Russell S. Long
USSN 10/662,112
Filed September 12, 2003

Application No. 10/662,112
Amendment dated August 18, 2005
Reply to Office Action of May 19, 2005

Annotated Sheet Showing Changes

2/16

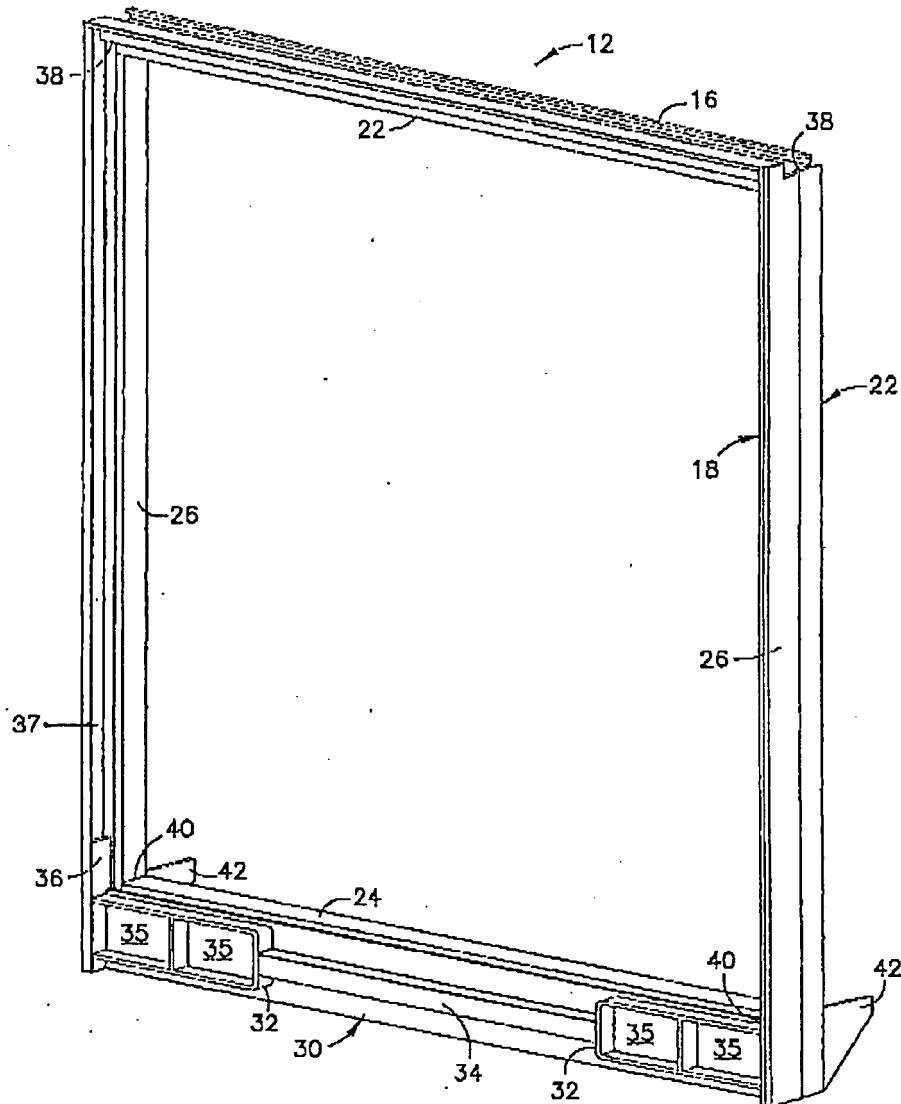
Applicants have amended FIGS. 2 and 4 by adding reference numeral 37. Reference numeral 37 points to a groove that extends substantially along the entire length of the exposed side of each side rail. Groove 37 is adapted to receive the stiffener member 36. The groove 37 was depicted in the original figures that were transmitted with the application. However, the groove 37 was not given a reference numeral.

Accordingly, Applicants have amended paragraph [0038] to state that the stiffener members 36 are received into a groove 37 that extends substantially along the entire length of the exposed side 18 of each side rail 62. Because the groove 37 was depicted in the original drawings that were filed with the application, the amendment to paragraph [0038] does not present an issue of new matter under MPEP Section 2163.06.
